Access Compliance Report

Public Rights-of-Way

Intersection ID: 42669	Main Street: THORNHAVEN_CT	Cross Street: WALLACE_CABIN_DR	Location: SW
ADA ID: 610DB2430CF2	Ramp Type: PerpDiag	Initial Pass/Fail: Fail	Overall Compliance: No
		Severity Score: 8.75

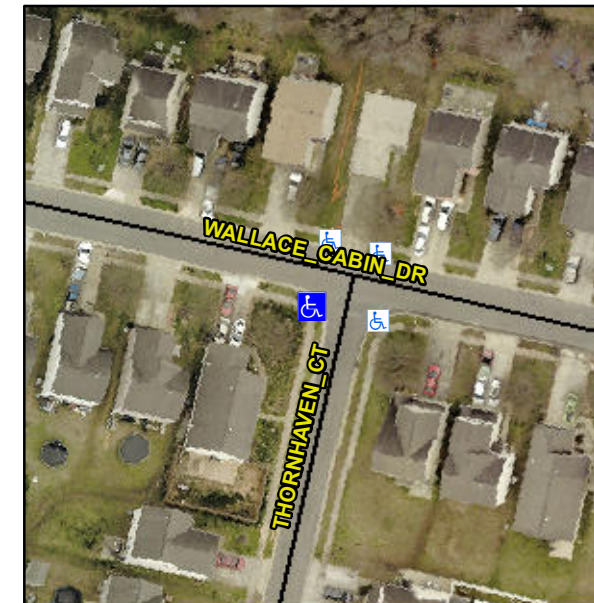
R304.5.1

Remove & Replace Curb Ramp With Two New Directional Ramps or Equivalent.
